N61165.AR.004218
CNC CHARLESTON
5090.3a

MISCELLANEOUS CORRESPONDENCE REGARDING CORRECTIVE MEASURES STUDY
SEPTEMBER 2001
9/01/2001
CNC CHARLESTON

RE: CMS Investigation Report Addendum
SWMU 159/AOC 653, Zone H, (Request for NFA)
Charleston Naval Complex
SC0 170 022 560

⊗ = Summit Wells.
FROM Figure 3-7
GW Contours.
GWMR.

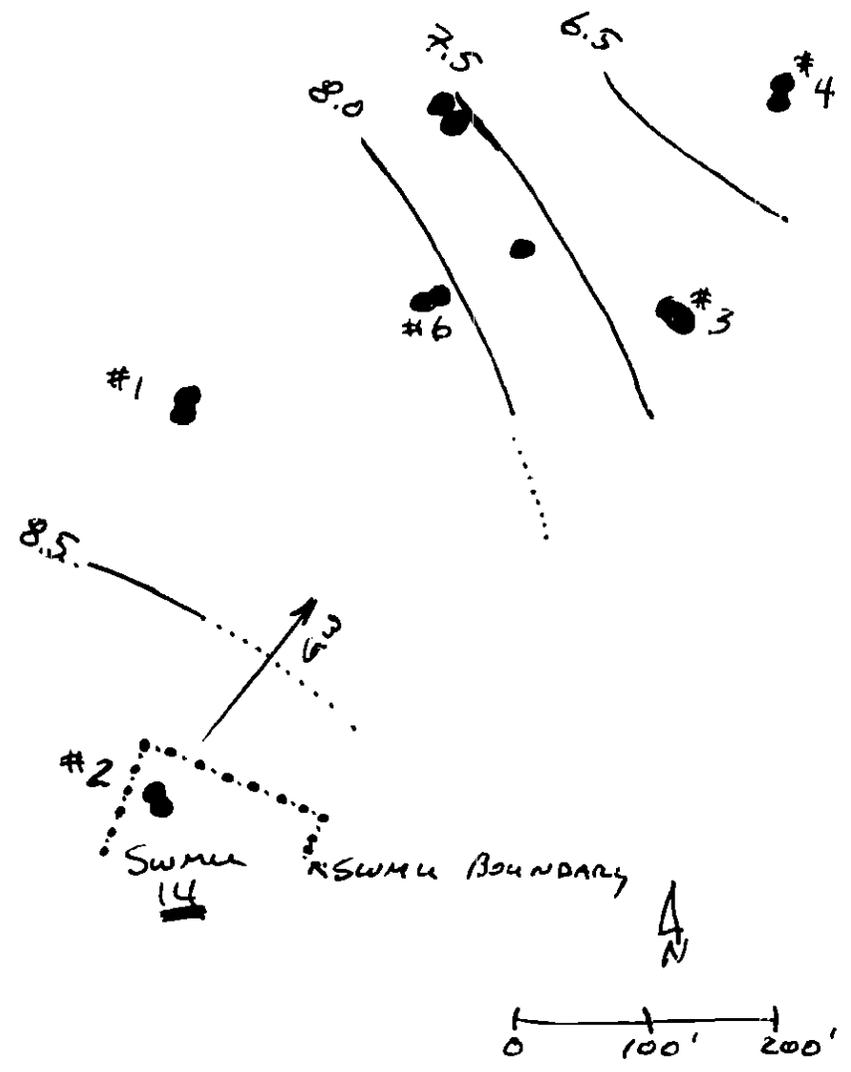
24. Groundwater contours from 10/16/1996 are represented in Figure 3-13. It has been suspected that sewer infiltration is the reason groundwater is flowing away from the Cooper River towards the northwest. That sewer line has since been repaired. The direction of groundwater flow should be verified in the next monitoring report.
